Zoning Staff Report

Case Number: ZC-25-088

Site Location: 1812 & 1820 W. Lowden Street

Proposed Use: Auxiliary parking lot

Site Plan

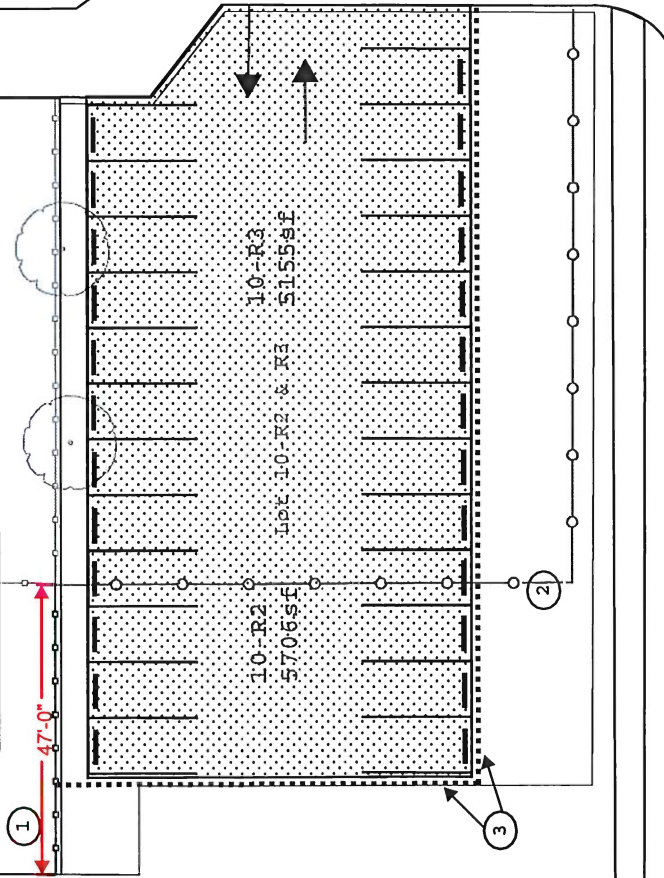
Zoning and Land Use

The site plan as submitted is not in general compliance with the Zoning Ordinance regulations. If approved, these comments would need to be addressed prior to ordinance adoption.

1. Add the Site Addresses and full legal descriptions (Subdivision/Block/Lots).
2. Add the title of project or development (in bold letters) in the lower righthand corner of the plan.

3. Add the date of preparation or revision.
4. Add the name, address, and telephone number of person drawing the plan and developer/owner.
5. Add a vicinity map, north arrow, and scale in a reasonable measurement.

6. Label the zoning case number in the lower righthand corner of the plan, below the title.
7. Provide a signature line labeled: "Director of Development Services" with a "Date" line above the project title.

8. The location and label of all existing structures on the site, including those proposed to be removed.
9. Add the label for Note #2 to the drawing.
10. Add the existing wood fence, metal panel, and metal pipe fence symbols to the fencing legend.

11. Solid 6-foot screening fences of wood/masonry/stucco are required on the northern, western, and southern sides. The metal panel and pipe fences are not allowed. Change the fence materials and note both the material proposed and height.

12. Fences are not allowed in front of the house to the north. Pull both the metal panel and pipe fences back to be behind the house's front edge.
13. Paving is not allowed in front of the house to the north. Pull the paving back to be behind the house's front edge.

14. Label the alley Right-of-Way width.
15. Dimension the driveway/aisle width.
16. Label the type(s) of the proposed parking lot surface material in the legend (concrete or asphalt).

17. Add the landscaping areas and sidewalks to the legend.
18. How will the western-most parking spaces turn-around without a bump-out turn-around?
19. Dimension the width and length of parking spaces.

20. Label or note the total number of parking spaces.
21. At least one ADA space will be required, based on the maximum number of parking spaces provided.

22. Show the access ramps and wheel stops/curbing.
23. Show and label all the required setbacks, including the 20-foot supplemental setback on the northern side. Some development waivers may not be needed if the southern front yard meets the required setback.

24. Parking is not allowed in this supplemental setback beyond daylight hours. A development waiver will be required to allow parking for a bar that closes at 2am. Add the note in bold **"This item is requesting a development waiver."**

25. A 5-foot landscaping buffer is required next to the northern property line. Show and label this required landscaping.
26. The majority of the site's landscaping is required to be in the front yard with the widest pavement width. Measure the adjacent street widths and add these pavement widths, then add the required landscaping areas to the appropriate front yard.

27. Add the tree diameter size 4.5 feet from the ground and their species.
28. Note no dumpster or storage will be allowed on-site.
29. Note if lighting will be on-site or not. If lighting is provided, show and label it.

30. If lighting is added, add the note that all lighting will be directed away from residential areas.
31. Auxiliary parking lots are required to be chained and locked over-night. Add the note in bold **"This item is requesting a development waiver."**

32. Show and label all the platted easements.
33. Label the land use and zoning classifications of the surrounding properties in all directions, as well as the subject site.

34. Add the note "This project will comply with [Section 6.301, Landscaping.](#)"
35. Add the note "This project will comply with [Section 6.302, Urban Forestry.](#)"

36. Add the note "All signage will conform to [Article 4, Signs.](#)"
37. Add the note "All provided lighting will conform to the Lighting Code."
38. Informational comment: Signage is not allowed on fencing or gates.

1. Access/use of the alley is subject to review by TDS. If alley is used, it must be paved to City standards, which will require engineered plans approved by the Infrastructure Plan Review Center and a Community Facilities Agreement. The Small-scale infrastructure program may be another route.

2. Driveway on Livingston will not be allowed - does not meet driveway spacing policy (75 feet from intersection minimum). This is especially true if using the alley for access on other side..

3. Access to lot using Alley-only is required. Driveway on Lowden would likely not meet intersection AND driveway spacing requirements.
4. Minimum aisle spacing for 90 degree head in parking is 24 feet. Dimensions not given for parking stalls. May be able to squeeze additional spots into the lot. Chapter 8.4 of the Transportation Engineering Manual for additional guidance.

5. Applicant may be able to pave alley with parkway permit instead of IPRC/CFA or SSIP.
6. Site plan will need to show curbing that will separate parking stalls from alley ROW. A standard driveway from the alley to the parking lot is required.
